PLANNING, ZONING, & BUILDING DEPARTMENT
PZ&B Staff Combination Memorandum: Architectural Commission and Town Council

SUBJECT: ZON-23-078 (ARC-23-112) 225 WORTH AVE (COMBO)

MEETING: AUGUST 09, 2023 TC
AUGUST 23, 2023 ARCOM

EXISTING SITE PLAN (REAR OF PROPERTY)

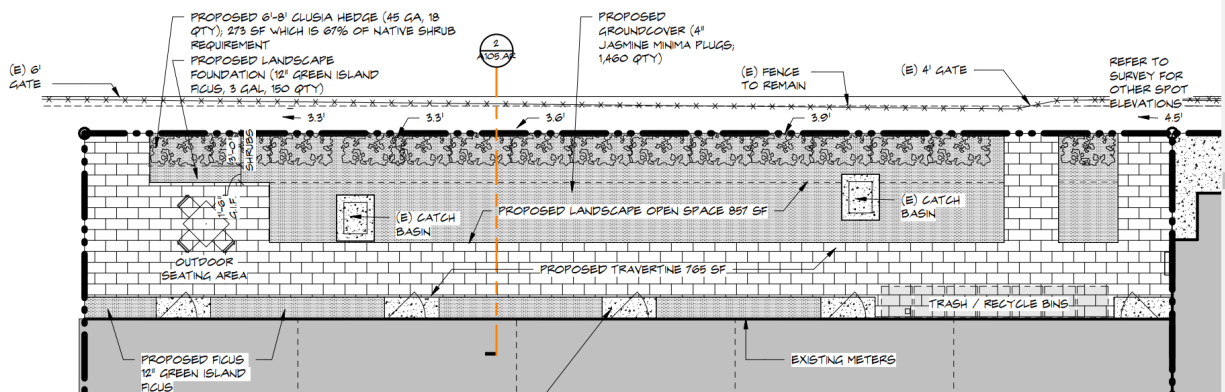
The existing conditions at the front of the property has minimal landscaping, provided in a small hedge area and potted plant and is limited based on sidewalk requirements along Worth Avenue; based on the previous approval for 12.5% of landscaped open space this would leave approximately 138 SF for hardscape areas which, according to the applicant, which is not adequate for pedestrian circulation and access to each of the separate tenant suites' rear egress doors. There is no negative impact from Worth Avenue or on neighboring properties as the proposed improvements are not visible from any right-of-way. It is the intent of the owner to install a consistent paving material for all of the tenants.

The applicant is considerably improving the existing site condition, and providing landscaping where such logical opportunities exist.
